## PCN

### Automatic production line for EPCOS NTC ICLs in Zhuhai

## Product / Process Change Notification

<b>1. ID No.:</b> PPD14/T122		<b>2. Date of announcement:</b> December 1, 2017	
<b>3. Product / product group:</b> EPCOS NTC ICLs	<b>Old ordering code:</b> B57234S* B57237S* B57238S* B57364S*	<b>New ordering code:</b> No change	<b>Customer part number:</b>
<b>4. Description of change:</b> <p>In order to expand production capacity and standardize production, we are installing another automatic reel line in Zhuhai, China. The above-mentioned series, which is to date produced in a semi-automatic strip line, will then be transferred to the new line. This involves the following changes:</p> <ul style="list-style-type: none"> <li>- Automation of wire-forming, soldering, coating, testing, marking and packing production steps.</li> <li>- Removal of the loop kink.</li> </ul> <p>These automated processes are already well-established for NTC inrush current limiters S153/S235/S236 and the P11/P13 series.</p>

Figure: Loop kink design

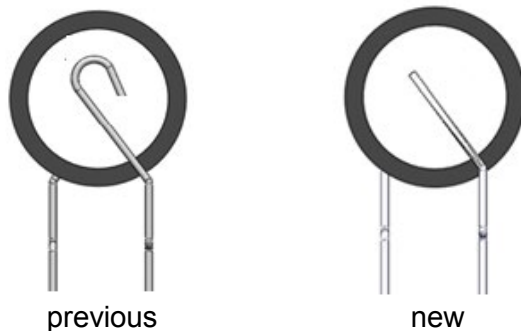
- Automation of wire-forming, soldering, coating, testing, marking and packing production steps.
- Change of the loop kink termination design from bent to straight.
